NL-16-0332
10 CFR 50.90

Southern Nuclear Operating Company
Joseph M. Farley Nuclear Plant Units 1 and 2;
Edwin I. Hatch Nuclear Plant Units 1 and 2;
Vogtle Electric Generating Plant Units 1 and 2;
Vogtle Electric Generating Plant Units 3 and 4
Response to Second Request for Additional Information Regarding
Standard Emergency Plan

Second Set of Requests for Additional Information On License Amendment Request For Fleet Standard Emergency Plan

Figure B.2.1.A – Technical Support Center Organization

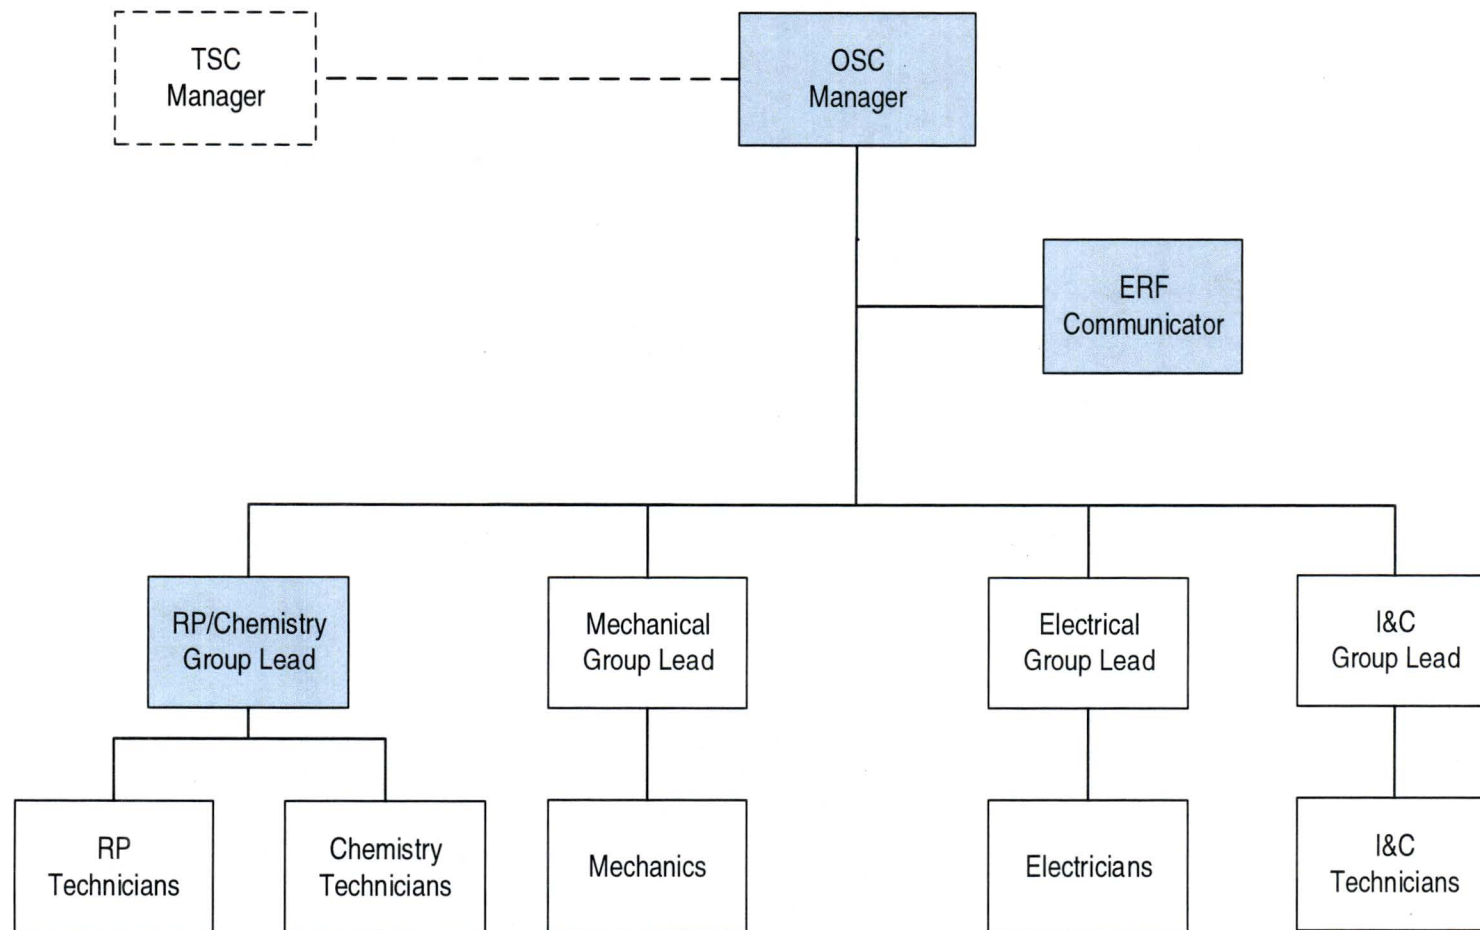
The FNP Augmented Emergency Response Organization is described in Figures B.2.1.A, B.2.2.A, B.3.1.A, and B.3.2.A in the Emergency Plan (SEP B.2, B.3).

The Standard Plan organization charts were added to provide the organizational structure of the various ERFs. Additionally, the minimum staff identified in Standard Plan figures B.2.1.A, B.2.2.A, B.3.1.A are not intended to further reduce the augmentation requirements, but instead delineate a subset of the 75 minute responders that, if available prior to full staffing, can 'activate' the facility and reduce the event management burden on the Control Room through transfer of command and control functions to the ERFs. The transition of Command and Control functions between ERFs is depicted in Section B of the Standard Plan (Figure B.2.A). Criteria for facility activation are included in Section H.4 of the Standard Plan and include achieving minimum staffing within the specific facility and completion of a briefing for facility personnel. This criteria was developed to comport with the guidance in NSIR/DPR/ISG-01, Emergency Planning for Nuclear Power Plants.

The minimum staffing identified in the Standard Plan Figure B.2.1.A (TSC) is compared to that described in the current Plan Section V.B.1, in the table below.

Current Plan Section V.B.1	Proposed Plan Figure B.2.1.A	Justification
Emergency Director	TSC Emergency Director	No change. Position supports Emergency Direction and Control function
TSC Manager	TSC Manager	No change. Position supports Emergency Direction and Control function
Operations Supervisor	Operations Supervisor	No change. Position supports Plant Operations and Assessment function
Health Physics Supervisor	RP Supervisor	Change in title only. Position supports Radiological Assessment /Dose Assessment functions
Engineering Supervisor	Reactor Engineer	Specified position responsible for Plant System Engineering/Core Damage Assessment functions
Maintenance Supervisor	None	Position not included as minimum staff in the proposed plan as there are no tasks associated with the transfer of command and control assigned. Maintenance Supervisor position continues to be assigned to the TSC and is a 75 minute responder.
